OCD HODD STATES								
Form 3160-5 (August 2007)	UNITED STATES DEPARTMENT OF THE INTERIOR BUREAU OF LAND MANAGEMENT SUNDRY NOTICES AND REPORTS ON WI			MAY 1		3 2013	FORM APPROVED OMB NO. 1004-0135 Expires: July 31, 2010		
				ELLS			5. Lease Serial No. NMNM056376		
Do not use this form for proposals to drill or to re abandoned well. Use form 3160-3 (APD) for such p					-enter an RECEIVED		6. If Indian, Allottee or Tribe Name		
SUBMIT IN TRIPLICATE - Other instructions on reverse							7. If Unit or CA/Agre	ement, Name and/or No.

I. Type of Well Ø Oil Well Gas Well Other							8. Well Name and No. MESCALERO "30" FEDERAL 006		
2. Name of Operator Contact: DAVID A EYLER CIMAREX ENERGY CO. OF COLORADQail: DEYLER@MILAGRO-RES.COM 3a. Address 3b. Phone No. (include ar							9. API Well No. 30-025-38594		
3a. Address 3b. Phone No 600 N. MARIENFELD, SUITE 600 Ph: 432-68 MIDLAND, TX 79701 /)	10. Field and Pool, or Exploratory APACHE RIDGE; BONE SPRING

Permanent Abandonment of Federal Wells Conditions of Approval

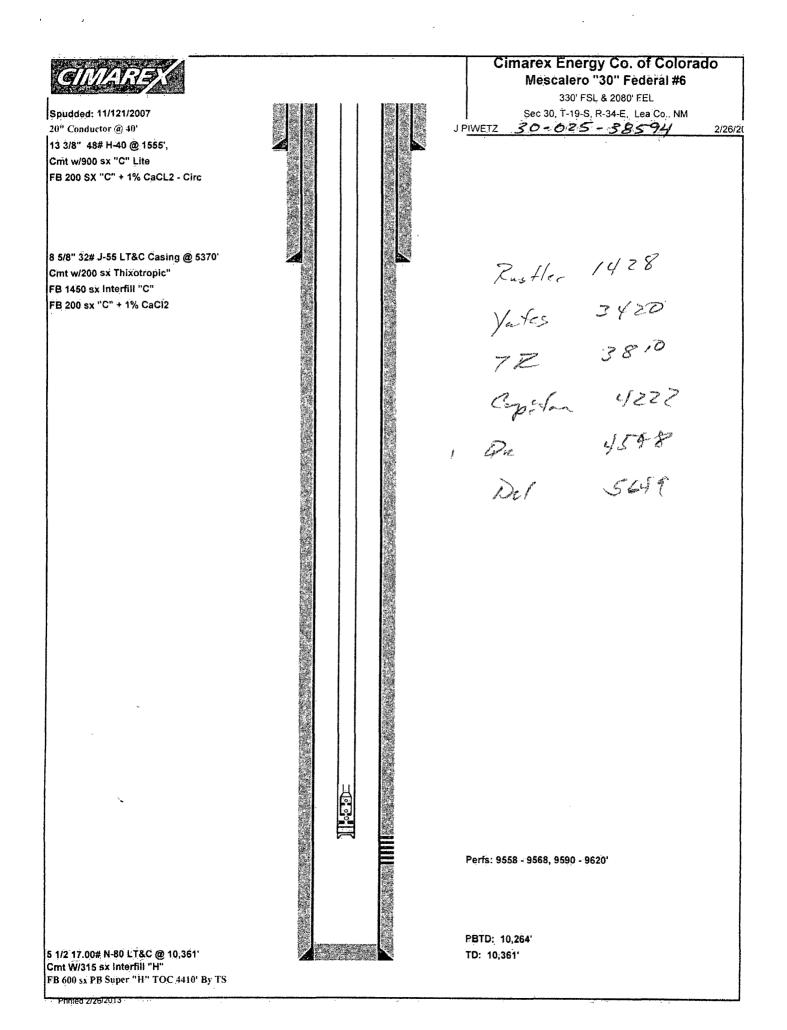
2) CIRC. WELL W/ PXA MUD; PUMP 25 SXS.CMT. @ 8,299'-8,119'(T/B.S.); WOC X TAG. 3) PUMP 55 SXS.CMT. @ 5,700'-5,320 '(T/DLWR X 8-5/8" CSG.SHOE); WOC X TAG. 5780'- 5420' 4) CUT X PULL 5-1/2" CSG. @ +/-4,000'. 5) PUMP 50 SXS.CMT. @ 4,070'-3,930'(5-1/2" CSG.STUB); WOC X TAG CMT. PLUG. * 6) PUMP 40 SXS.CMT. @ 1,610'-1 ,500'(13-3/8" CSG. SHOE); WOC X TAG CMT. PLUG. 1400' 7) MIX X CIRC. TO SURF. 25 SXS.CMT. @ 63'-3'.								•

8) DIG OUT X	CUT OFF WEL	LHEAD 3' B.G.L.; WELD ST from 3476'-3	EEL PLAT	E ONT	O CSGS	. X INSTAL		KER.	
		SE				E ATTACHED FOR			
Ground Level Day Hole Macker Reg					conditions of Approval
